Subject: LaSalle County Station Unit 2  
Response to Confirmatory Action Letter  
NRC Docket No. 50-374

Reference: A. B. Davis letter to Cordell Reed dated  
March 17, 1988 transmitting CAL-RIII-88-03.

COMMONWEALTH EDISON COMPANY RESPONSE TO

THE MARCH 17, 1988, CONFIRMATORY ACTION LETTER (CAL)

FIGURE 3  
LPRM AXIAL PHASE RELATIONSHIP

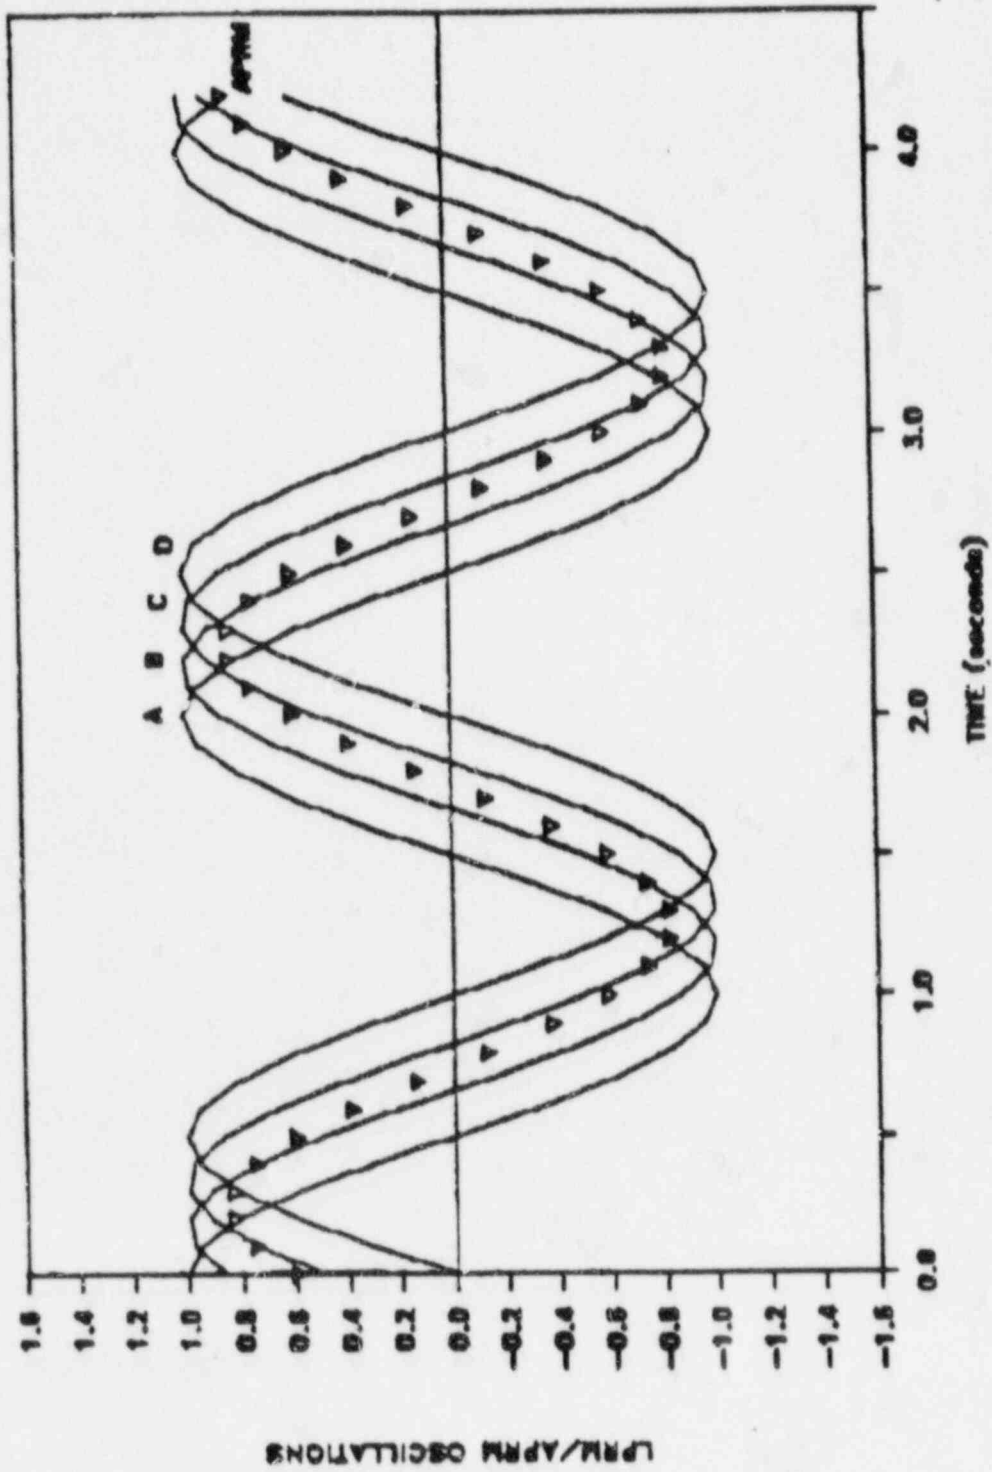
Q.1 Power Distribution - LPRM alarms occurred at an APRM level of 87 percent. This implies a shift in power distribution, since there should normally be substantial margin to the high LPRM level when APRM level is at 100 percent. Provide the available information on power distribution prior to the event and explain why LPRM alarms were triggered at the 87% APRM level. Is the LPRM Hi setpoint level equivalent to 105 watts/cm? Is it based on the allowable LHGR or simply to indicate that the instrument is off scale?

An analysis has been performed for the LaSalle-2 conditions at the onset of oscillations. The response of the LPRMs assigned to APRM Channel A have been modeled by a higher order sine wave (necessary to match the known non-linear characteristics of the oscillations). The LPRM with the highest average reading is assumed to oscillate up to 100% of scale (LPRM Upscale alarm setpoint) and the remaining LPRMs in APRM Channel A are assumed to oscillate with the same relative magnitude. This assumes that the peak-to-peak magnitude normalized to the average value is relatively constant for all LPRMs in the core (i.e., no shift in "peaking" during the oscillations). This assumption has been previously proposed and supported by data from the Vermont Yankee Stability tests. For the LPRM levels above the boiling boundary (B, C and D), the relative oscillation magnitude is assumed to be 1.2 times the relative magnitude for the A level LPRMs to account for the increased sensitivity to density perturbations in the voided regions (higher void coefficient). This relationship was also determined from the Vermont Yankee test data.

The APRM signal is the average of the 21 LPRMs assigned to the channel with an appropriate gain adjustment determined from the known values prior to the pump trip. The phase lag between the four LPRM detector levels is based on actual test data from Caorso which shows approximately an 8° shift from the A to D level. Figure 4 shows the results of the above analysis. For the peak LPRM oscillation just up to the LPRM Upscale alarm setpoint, APRM A is predicted to reach 84.5% of rated which is very close to the value estimated from data recorded during the event. The analysis also predicts that several of the D level LPRMs will go below the LPRM Downscale setpoint (5% of scale) and that LPRM Downscale alarms should occur before the first LPRM Upscale alarm is reached. The analysis also estimates that for APRM oscillations with a peak of less than approximately 74% of rated, no downscale alarms should occur. From the Hathaway Event
